## PUBLIC UTILITIES COMMISSION

July 20, 2018

RE: Sanger Substation Expansion Project—Review of Minor Project Refinement #2 Request

# **Exhibit 1: MPR #2 Map**

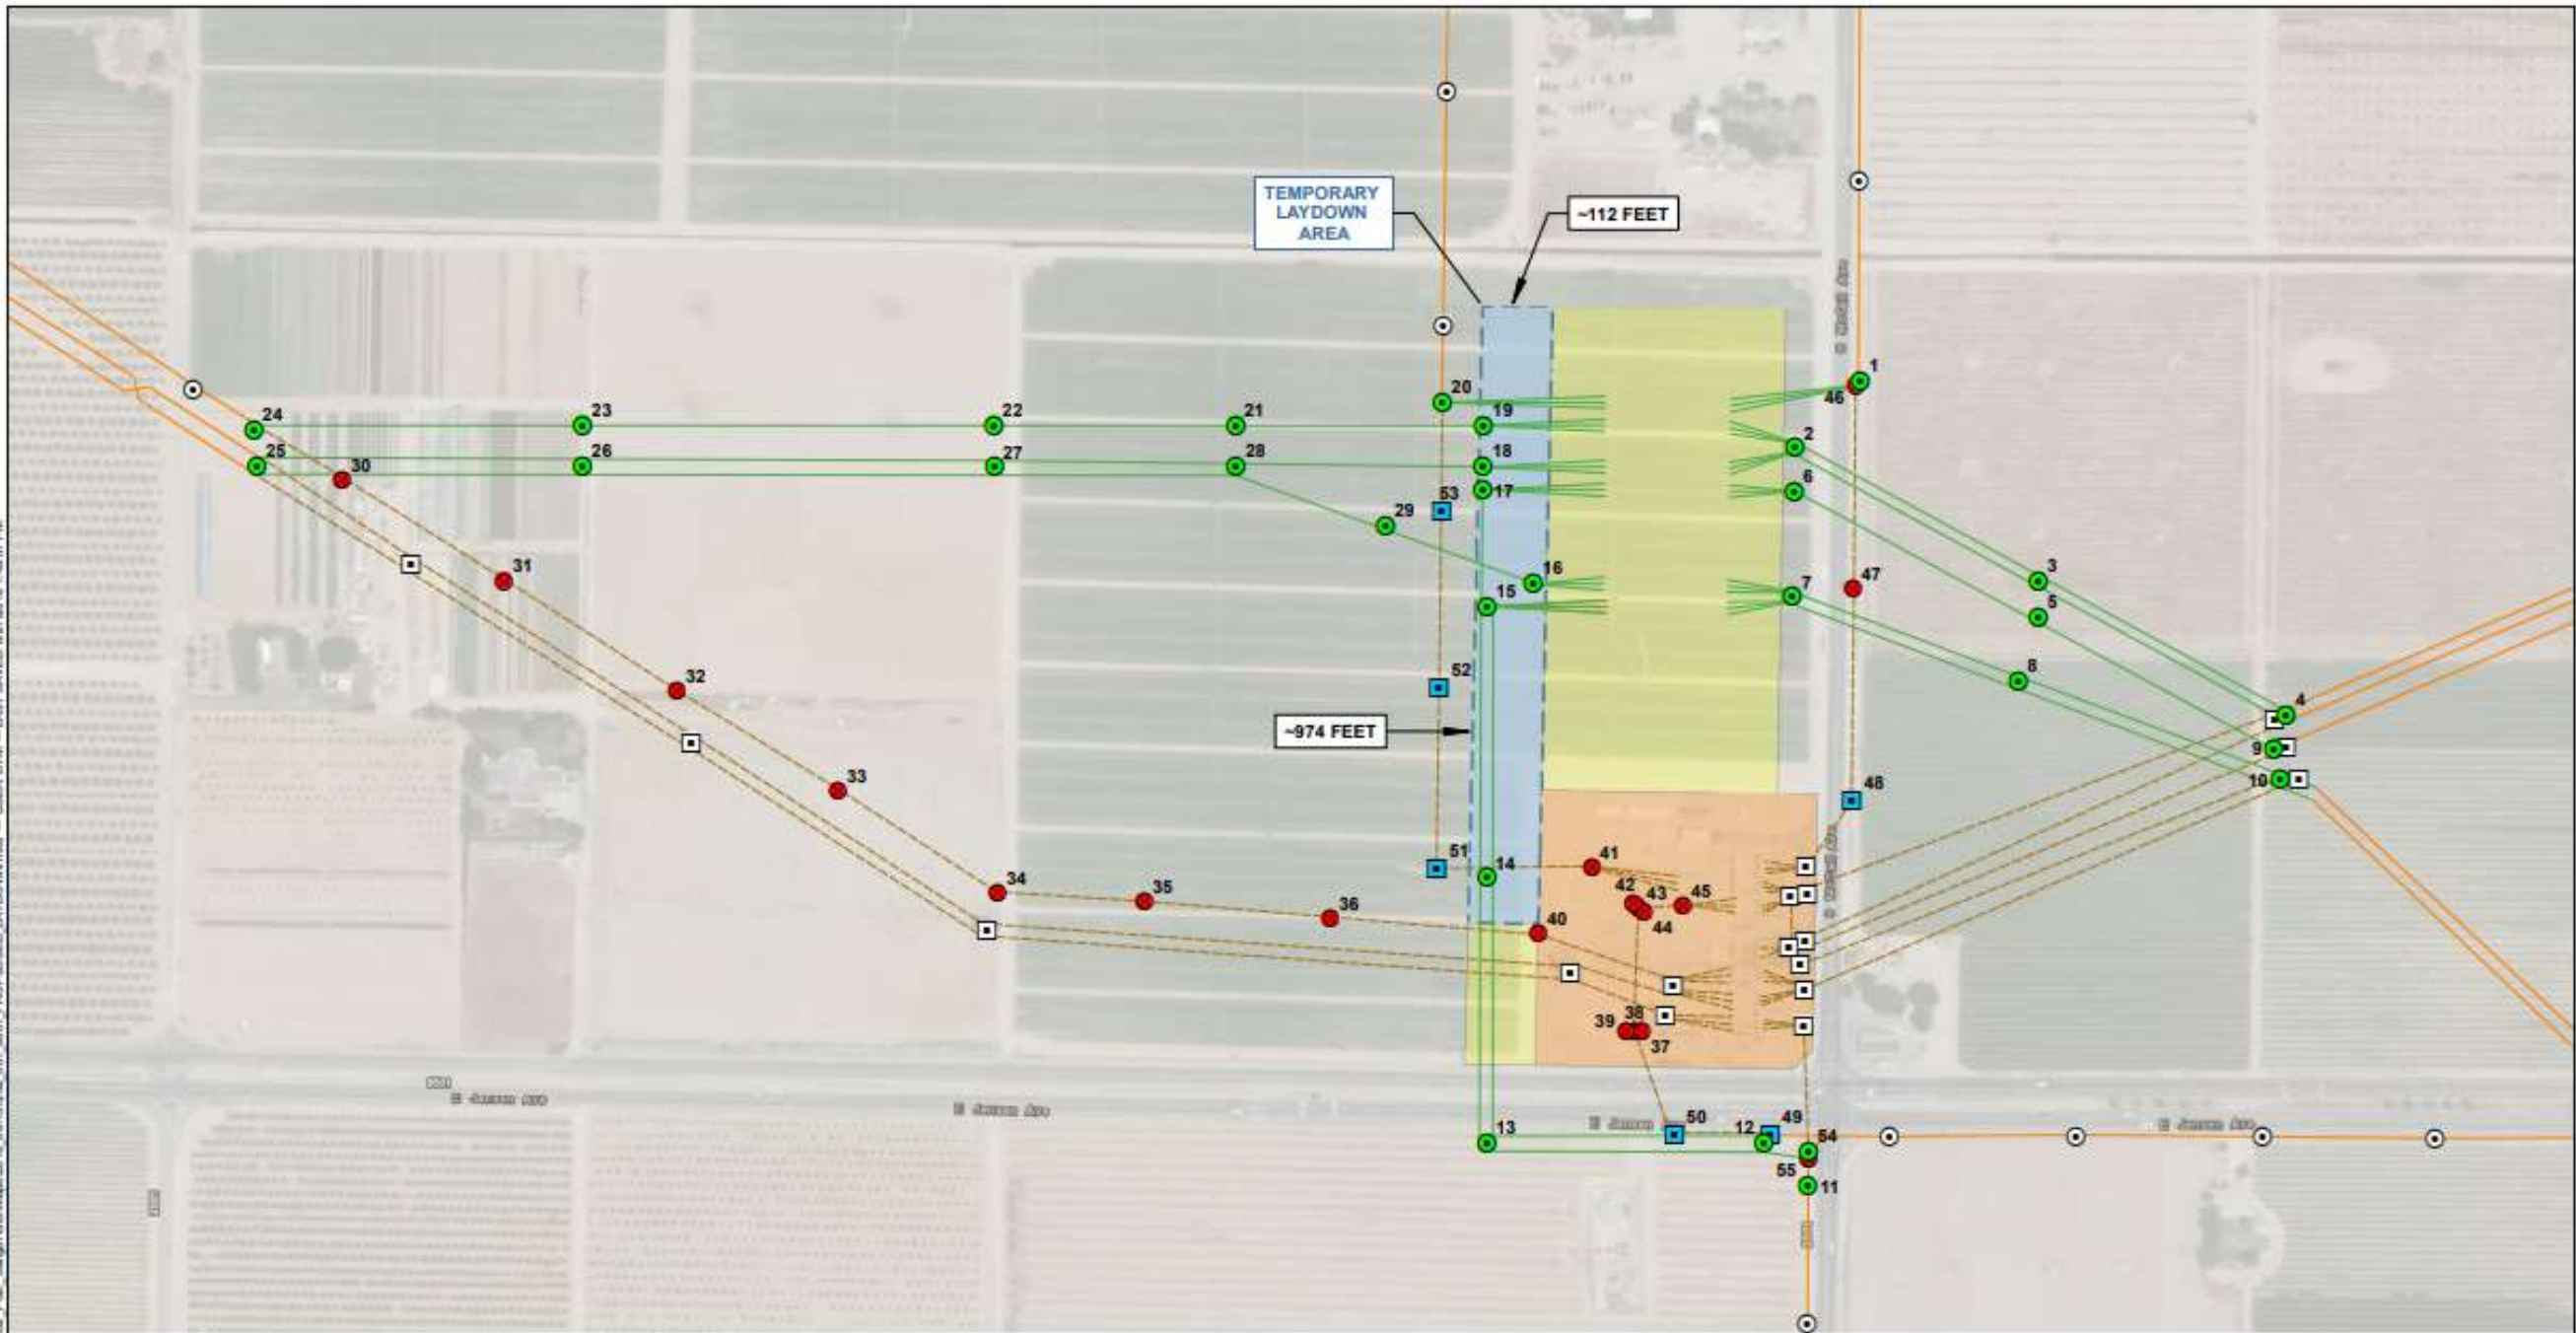
On June 29, 2018, PG&E submitted the revised request for Minor Project Refinement (MPR) #2 for approval by the California Public Utilities Commission (CPUC) for the Sanger Substation Expansion Project (project). The proposed MPR would include the use of an approximately 974-foot-long by 112-foot-wide additional temporary staging area within an area currently owned in fee title by PG&E. The area is located north of the proposed retention basin, and would continue to run north along the new western boundary line of the substation expansion area. The proposed new staging area would be used to store new tubular steel poles (TSPs), wood poles, and other equipment related to the transmission line scope of project work. PG&E proposes installing temporary fencing around the boundaries of the new staging area, and would remove the temporary fencing upon project completion.

- The temporary use of an approximately 974-foot-long by 112-foot-wide additional temporary staging area, within the area now owned in fee title by PG&E. This area contains approximately 0.66 acres of Farmland of Statewide Importance and approximately 1.83 acres of Prime Farmland. The proposed area would be used to store new TSPs, wood poles, and equipment related to the proposed transmission line expansion.
- The installation of temporary fencing surrounding the proposed staging area, to be removed upon completion of construction.

The proposed refinement area is currently farmed by the previous landowner; however, no farming was planned to take place in this area during construction of the project. The temporary staging area for the proposed refinement consists of approximately 0.66 acres of Farmland of Statewide Importance and approximately 1.83 acres of Prime Farmland. This would increase total project temporary disturbance acreage to agricultural lands to approximately 16.77 acres of Prime Farmland (from 14.94 acres) and approximately 7.56 acres of Farmland of Statewide Importance (from 6.90 acres).

Per MM AGR-1, the proposed refinement area would be restored to pre-construction conditions following project completion. Therefore, staging activities within the proposed refinement area would not result in a permanent conversion of either Prime Farmland or Farmland of Statewide Importance.

All work areas will be clearly delineated with signs, lathes, and/or flagging to ensure construction personnel stay within approved project limits, and the applicant has proposed installing temporary fencing surrounding the proposed staging area.

MPR #2 is approved by the CPUC with conditions. The conditions presented below shall be met by PG&E and its contractors:

1. All applicable Project MMs, APMs, compliance plans, and permit conditions shall be implemented. Some measures have on-going/time-sensitive requirements and shall be implemented prior to and during construction, where applicable. Prior to construction, PG&E must submit all applicable permits to the CPUC.

2. Copies of all relevant permits, compliance plans, and this MPR, shall be available on site for the duration of construction activities.
3. Wildlife found to be trapped shall be removed by a qualified biological monitor.

4. PG&E shall implement appropriate dust controls at the MPR #2 work area in accordance with the approved Dust Control Plan, and SWPPP.
5. PG&E shall implement all appropriate erosion and sediment control BMPs for the MPR #2 work area as defined in the SWPPP, and as specified by the Qualified SWPPP Practitioner. Sediment and erosion control BMPs shall be properly maintained throughout the duration of construction activities.

6. All ground-disturbing activities (e.g., grading, trenching, etc.) shall be monitored by a CPUC-approved biological monitor, archaeological monitor, and paleontological monitor in accordance with MM BIO-3, MM BIO-4, MM CUL-1, and MM CUL-4, where appropriate. In the event of observation of sensitive biological resources onsite, or an archaeological or paleontological discovery, all construction activity associated with MPR #2 shall be halted, and procedures shall be followed in accordance with the appropriate mitigation measures and protocols. If a cultural resource is encountered and is determined to be associated with California Native American Tribe(s), PG&E shall coordinate with the CPUC and with the Tribe(s) to determine appropriate mitigation procedures, as discussed in MM CUL-5.
